Surround preamp

bygselvhifi.dk

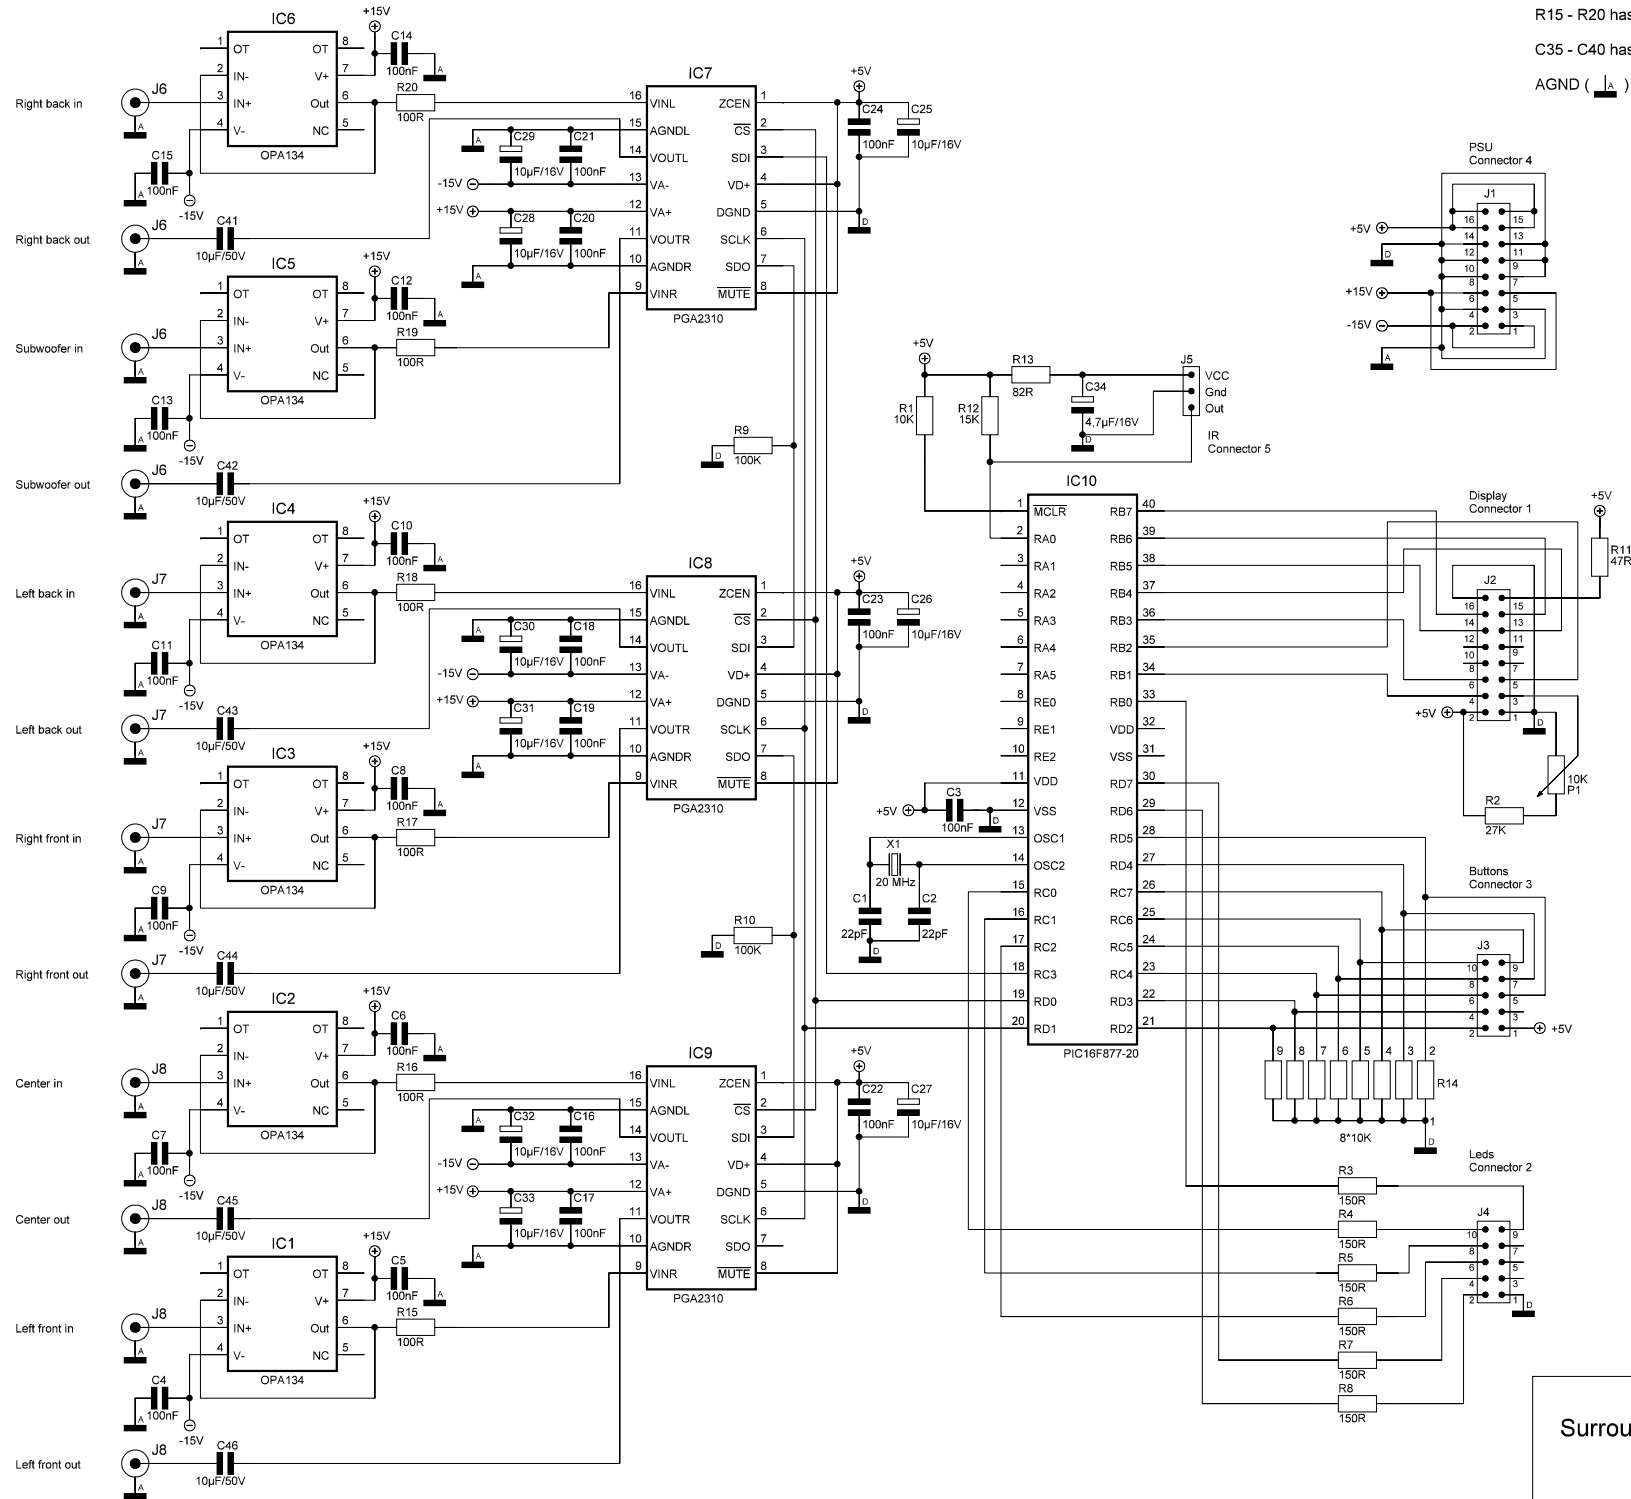
R15 - R20 has been added to the PCB as a modification

C35 - C40 has been removed from the PCB as a modification

AGND (**A**) and DGND (**B**) are connected together at connector 4
